SERVICE BULLETIN

ENGINE — WASHER — REPLACE THE HIGH PRESSURE COMPRESSOR
(HPC) REAR DRUM WASHERS TO REDUCE THE POTENTIAL OF 12TH STAGE
ROTOR CRACKING DUE TO ASSEMBLY ERROR

REVISION NO. 1 - December 14/18

V2500-ENG-72-0687

LOCATION OF WASHER
72-41-13
FIGURE 1

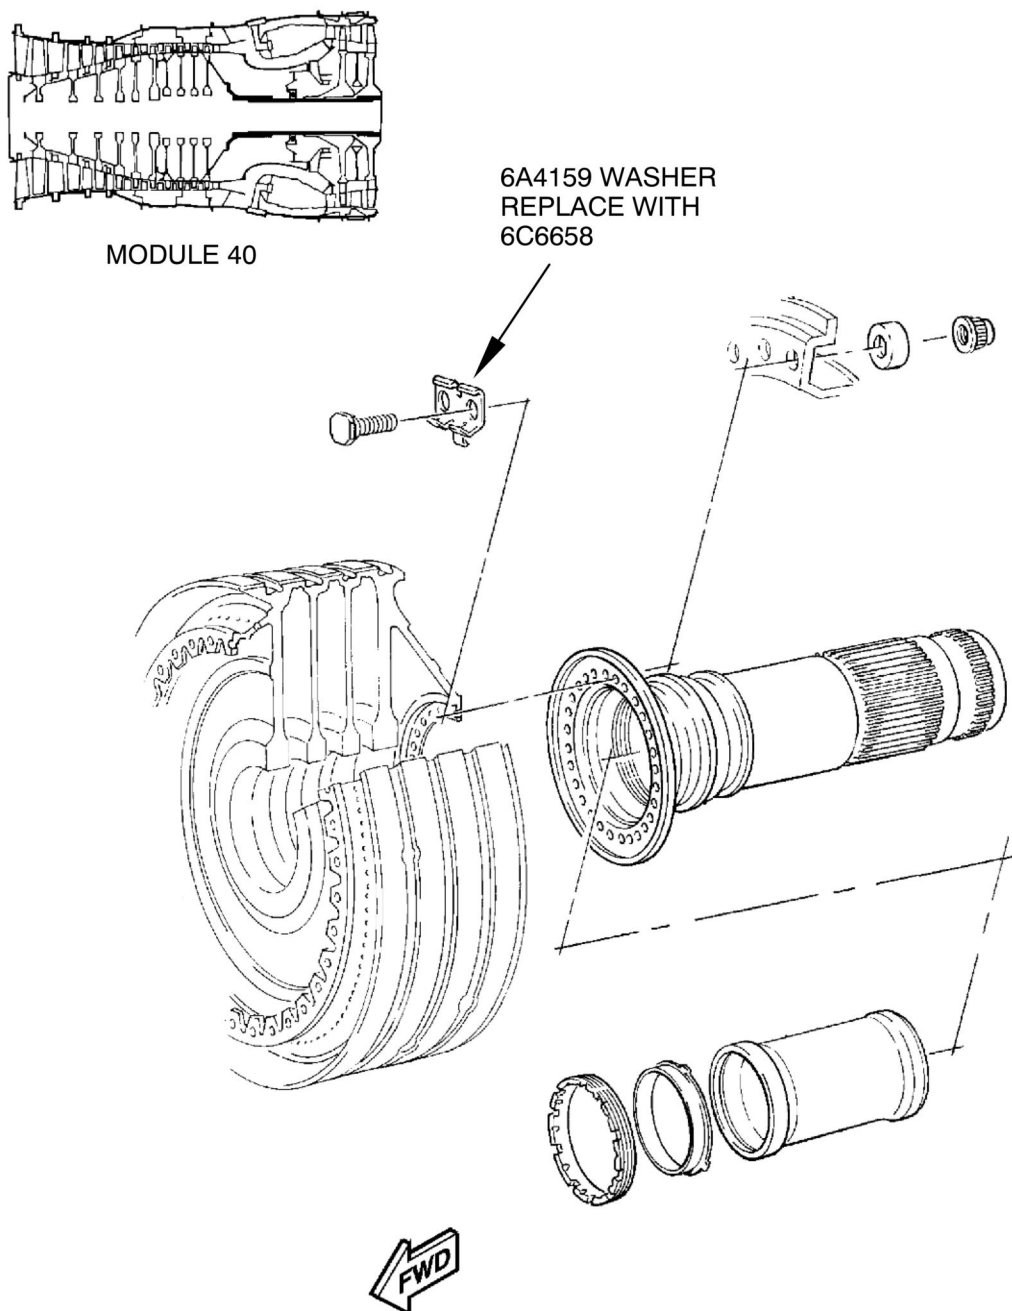
The purpose of this Service Bulletin is to replace the fourteen (14) HPC rear drum washers with a redesigned washer that eliminates the tab. The old tab washer design had the potential to cause stage 12 rotor cracking when incorrectly assembled.

1. Condition: The HPC 9-12 drum may exhibit cracks in the 12th stage rotor as a result of aggressive tab washer assembly. This Service Bulletin provides a new washer design, assembly tool, and assembly process that will reduce the potential for cracks.

2. Background: During assembly of HPC 9-12 drum a drift and hammer are used to strike the washer to bend the tabs in place. During maintenance of an engine, cracks were found on the 12th stage rotor near the rear of the drum.

Replace the fourteen (14) washers.

1. Replace the fourteen (14) Washers PN 6A4159 with PN 6C6658 and assemble the HPC assembly as specified in Reference 6, V2500 A1/A5 Engine Manual, Task 72-41-10-440-002-B00 or Reference 7, V2500 D5 Engine Manual, Task 72-41-10-440-002.

LOCATION OF DATA PLATE
72-41-00
FIGURE 2

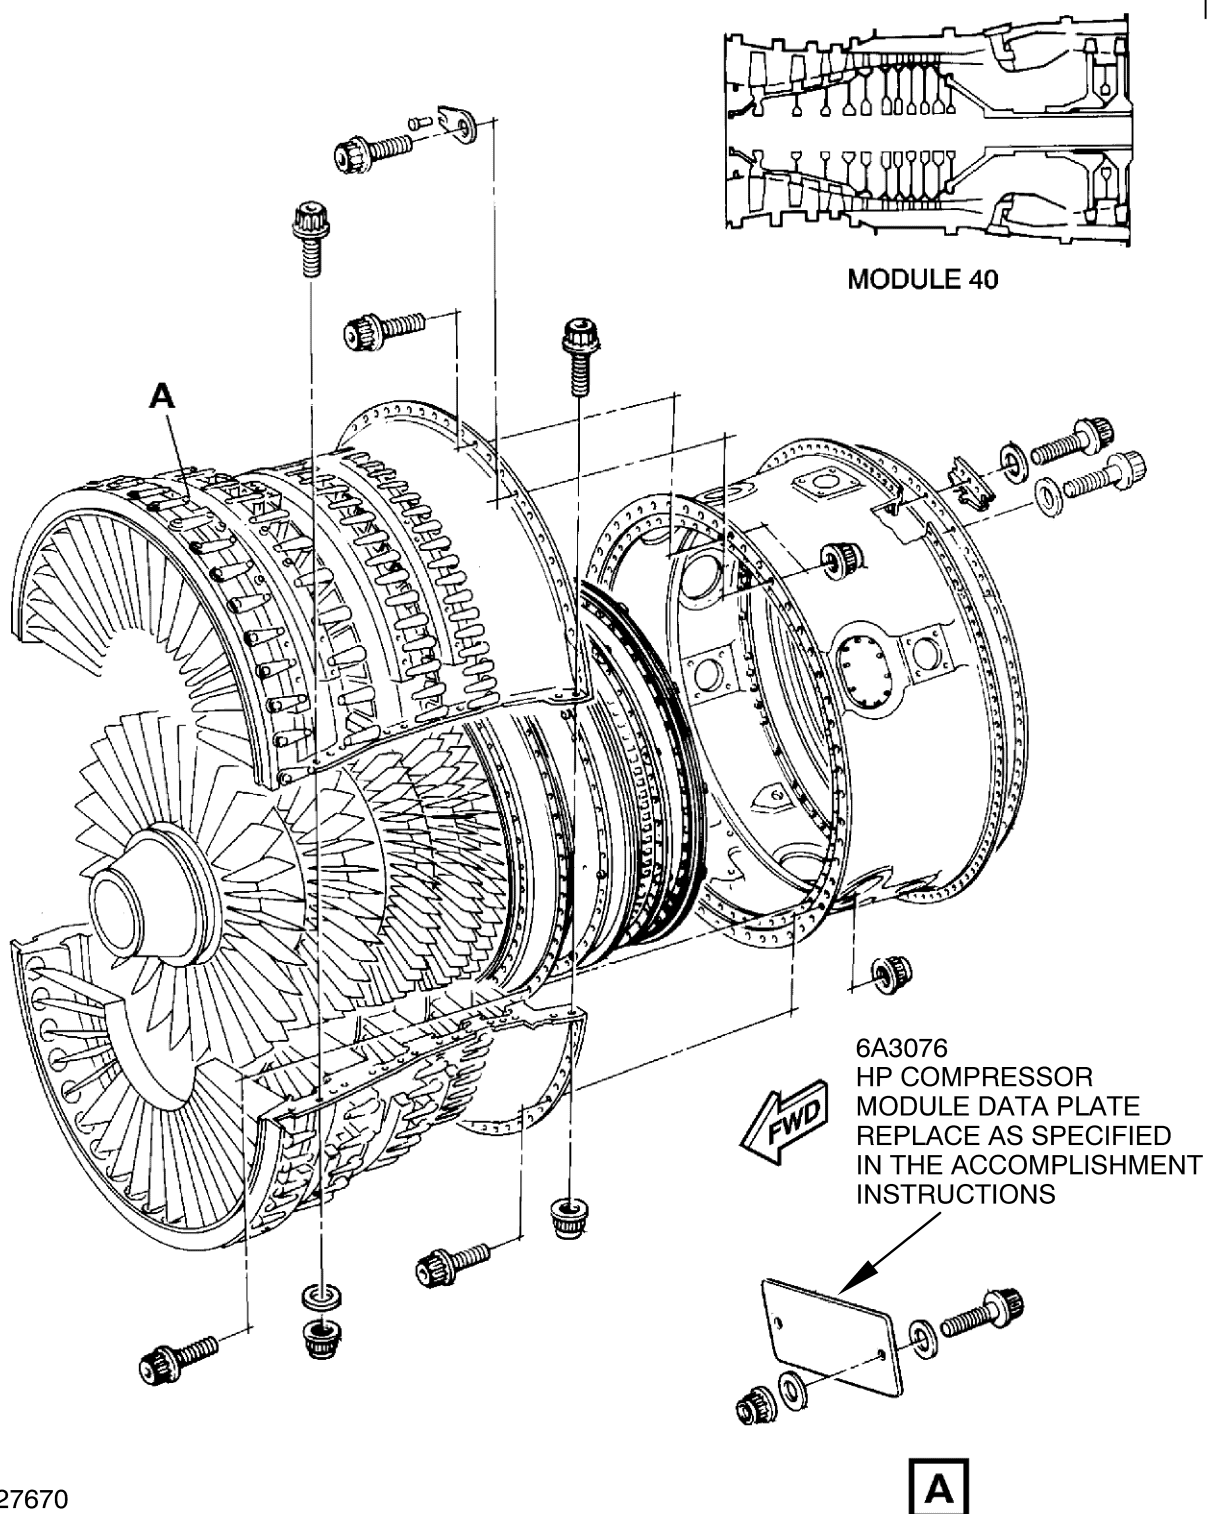
2. Reidentify the HP Compressor Module Identification Plate as follows:
 - A. Locate the HP Compressor Module data plate on the HPC front case. See Figure 2.

- B. Remove the attaching nuts and bolts and existing HP Compressor Module data plate
 - C. Obtain a new HP Compressor Module Data Plate, PN 6A3076.
 - (1) Mark the new data plate with the existing serial number as specified in Reference 3, V2500 Standard Practices and Processes, Chapter/Section 70-09-00.

- (a) Refer to Reference 8, Service Bulletin No. V2500-ENG-70-0991 for applicable HP Module part number.
 - D. Install the new HP Compressor module data plate into the location of the removed data plate.

- (1) Torque the nuts and bolts to 36 - 45 lbf.in (4.1 - 5.1 N.m) as specified in Reference 3, V2500 Standard Practices and Processes, Chapter/Section 70-41-00.
